## Narrabri Coal Project

### Response to Public and Government Agency Submissions Provided by the Department of Planning

June 2007

**Figure R2** presents the locations of the proposed monitoring bores of the GMCP.

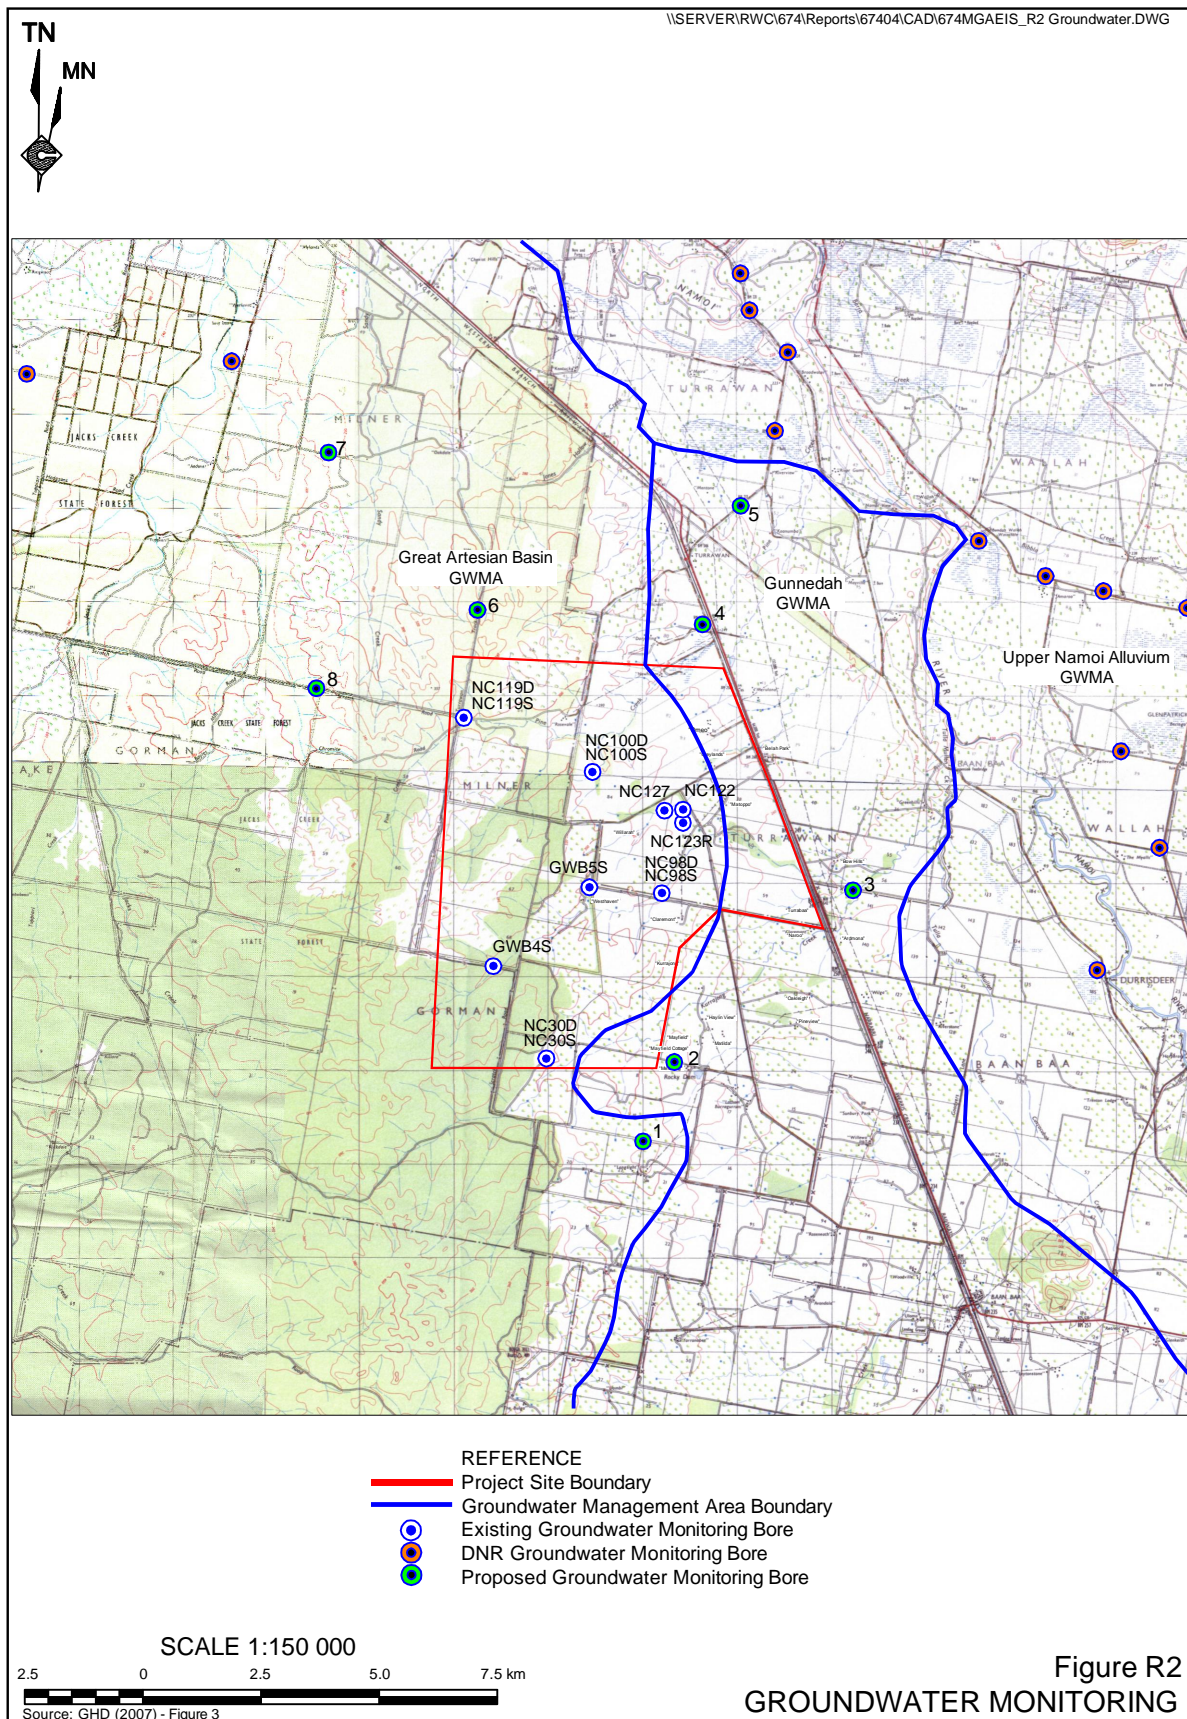
**Submission 11(c)** - *It is recommended that the contingency plan for loss of groundwater for local users be a condition of development approval. The contingency plans should specify the remedial actions as well as any compensation measures.*

The Proponent's commitment is re-stated to preparing and implementing a comprehensive and detailed Groundwater Monitoring and Contingency Plan (GMCP), to the satisfaction of the Director-General of the Department of Planning, the Department of Water and Energy and potentially-affected water users.

**Figure A1.4 Post mining predicted flows at NW model boundary**

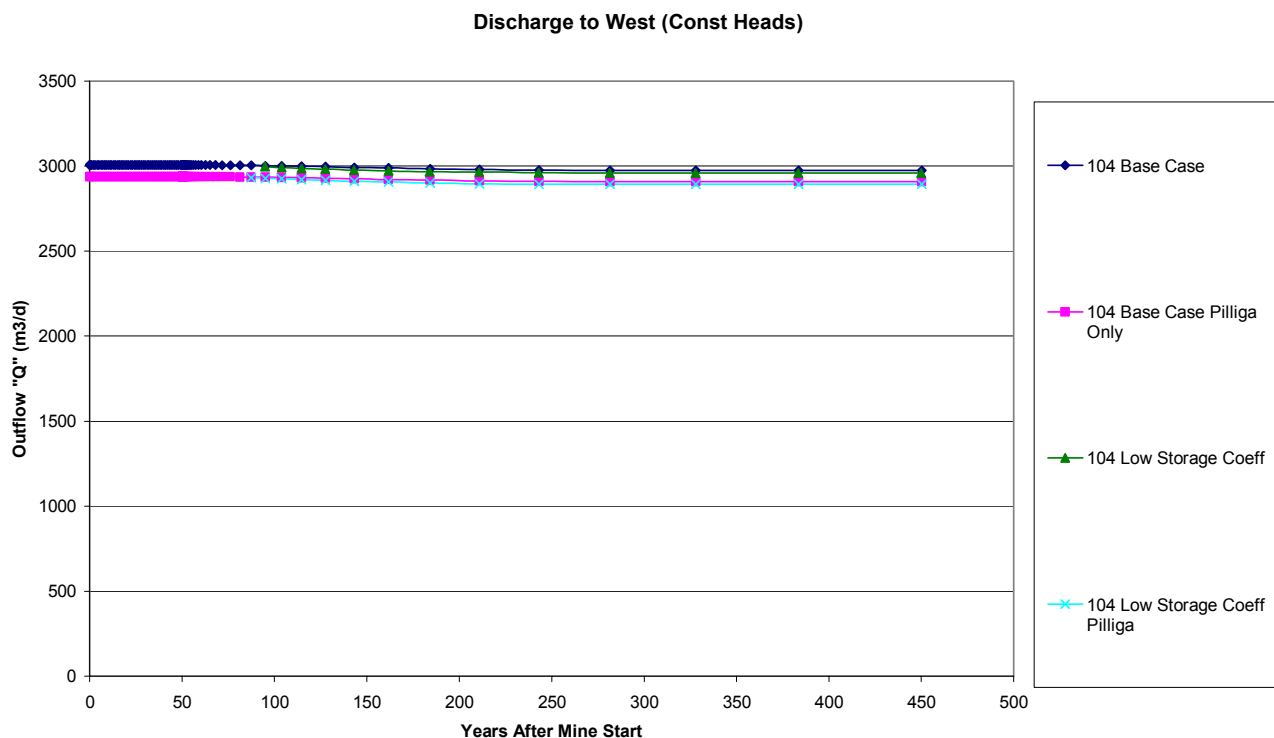
The Groundwater Assessment report states in Section 6.91 that the flow across the constant head boundary on the northwest of the model domain, representing inflows to the Great Artesian Basin, remains unchanged at 3005m<sup>3</sup>/d during mining and for a period of 50 years after mining. The model run was extended to 500 years to assess the post closure impact on recharge to the GAB and the results are shown in **Figure A1.4**. The total flow across the boundary with no mining impact is 3005m<sup>3</sup>/d of which 2937m<sup>3</sup>/d (98%) is comprised of flow in the Pilliga Sandstone as it the most permeable model layer. The flows across the boundary begin to decline marginally around 60 year and stabilise after 350 years. The long term reduction in the flow across the boundary in the Pilliga Sandstone is estimated to be 30m<sup>3</sup>/d (0.35L/s) which represents 1% of the pre-mining flow within the model domain. Therefore the post mining impact on flows to the GAB is estimated to be minimal. This figure is considered to represent a maximum value as due difficulty in re-wetting mine void cells in MODFLOW, recovery of pressures in the mine area are considered to be underestimated.
